**Item 14.****Development Application: 145 Young Street, Redfern****File No.: D/2018/236****Summary****Date of Submission:** 12 March 2018**Applicant:** Mr Frank Seebacher**Designer:** Design Plus Drafting**Owner:** Mr Frank Seebacher and Mrs Justine Smith**Cost of Works:** \$83,600**Proposal Summary:** The subject application seeks consent for alterations and additions to an existing dwelling house at 145 Young Street, Redfern.

**Figure 4:** Proposed Roof Plan.

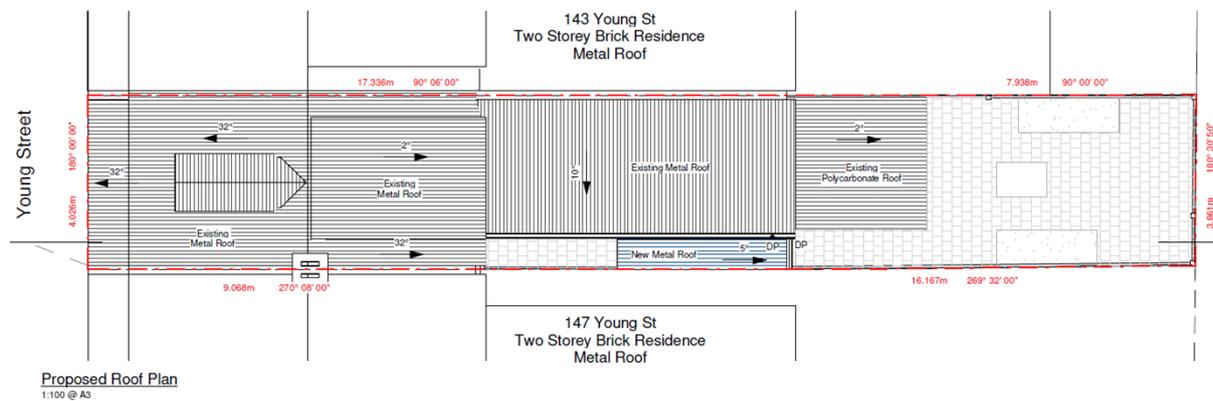
18. The proposed location of the light and ventilation shaft on front verandah is not supported as:
  - (a) it is uncharacteristic to Victorian terraces within the conservation area;

- (b) is considered to have a prominent and visible position from the public domain; and
  - (c) alters the principal facade of the contributory building as viewed from Young Street.

19. It is recommended that a condition be imposed requiring the deletion of the light and ventilation shaft. There is no amenity or building code issue with removing this shaft, as the room it is proposed to service is a storage area and is not a habitable room.
